Cambridge City Council

SOUTH AREA COMMITTEE

Planning Update Sheet

Comments on Application for Single Storey Rear to 255 Hills Road, Cambridge, Cambridgeshire CB2 8RP - Application Number 10/0996/FUL

WALL

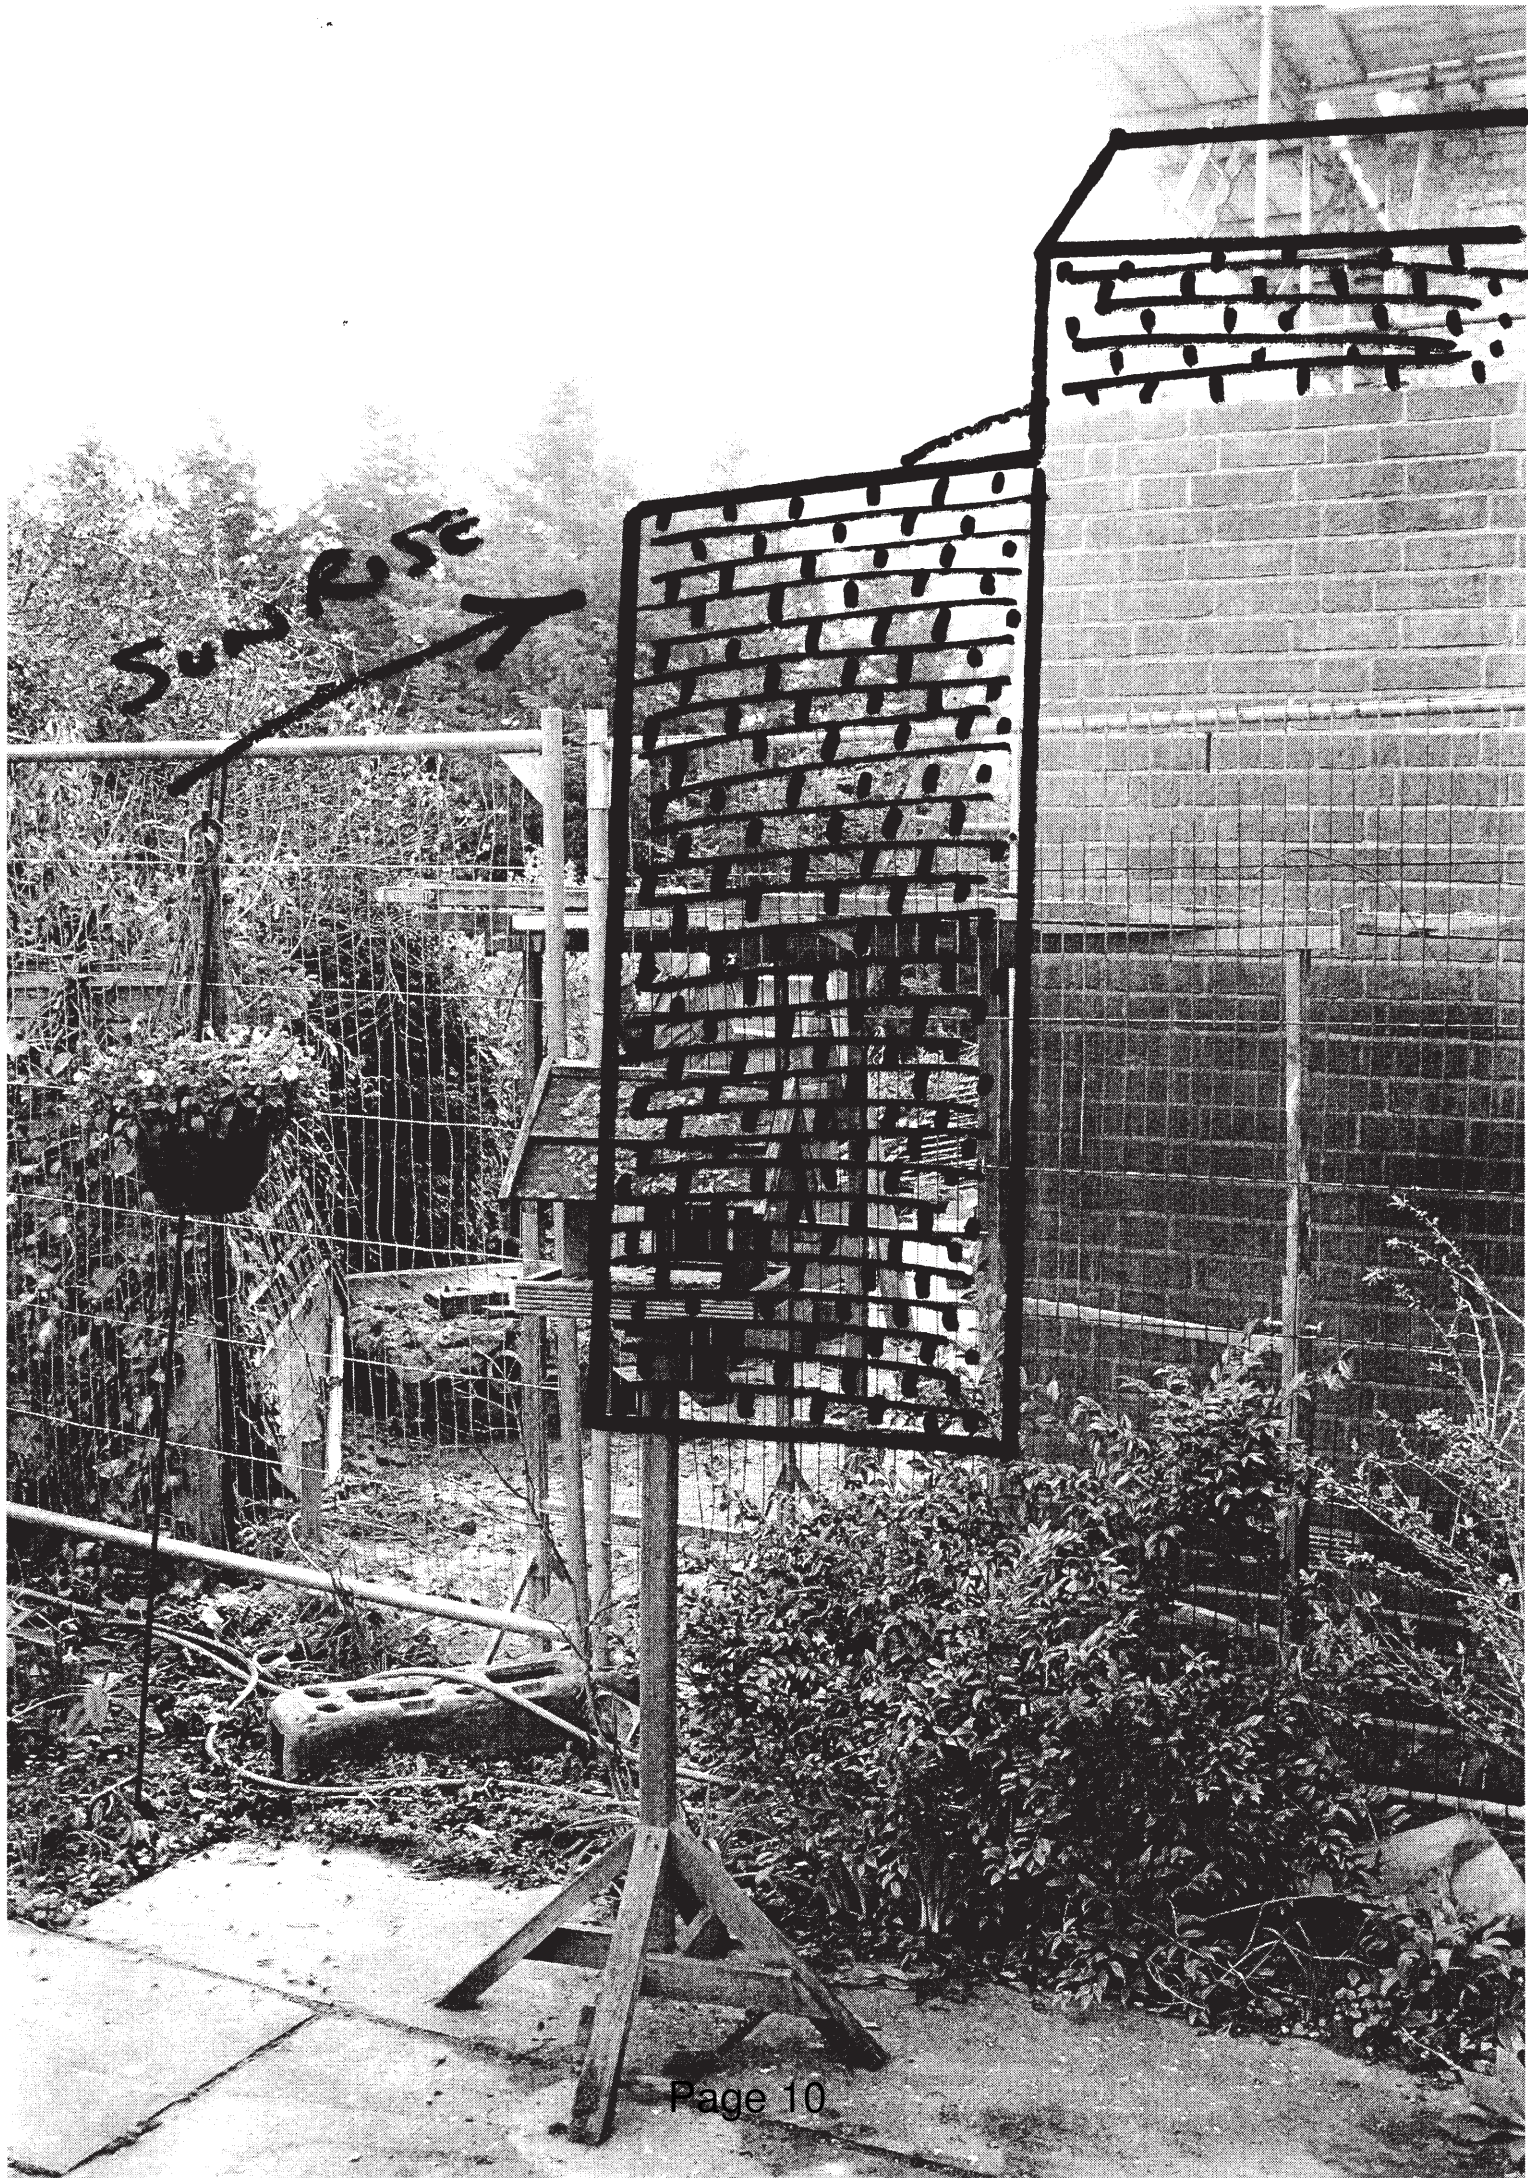
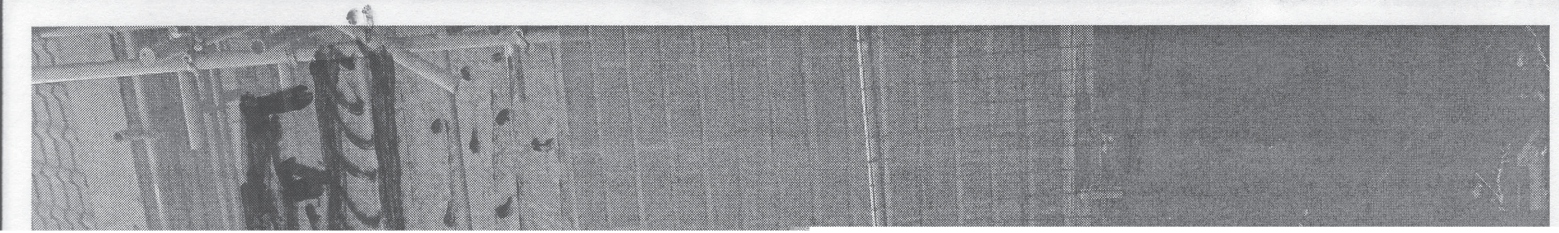
2. In particular, the attached neighbour (myself) lies to the north so that these additions have successively taken the light from the rear of our house. The intended further extension will take the last of this. I attach photographs which show a near-to-completion permitted extension, together with the proposed addition which is the subject of the Application.

The proposed extension is 2.5 metres in depth, 4.8 metres in width and 3.25 metres in height above the neighbours ground level. This height and bulk together with its positioning in proximity to the neighbours property means that it will cause yet more, loss of direct light to its neighbours. The stream of development work that has so far been approved has progressively lead to what now would amount to complete loss of direct light to the rear of the adjacent house.

The highest point (3.25m) of the proposed extension is significantly above the fence line and so will visually impact on its neighbour causing yet more overshadowing and visual domination.

The proposed addition extends a further 2,5 metres back from the rear of the house adding to the 3 metres of the permitted new extension giving a total of 5.5 metres. Besides its combined bulk, this extends the rear line of the property over two metres from the furthest rear wall of the house and so infringes a line that has been respected by all of its neighbours since they were constructed,. This further incursion is therefore out of context with the current house and its neighbours
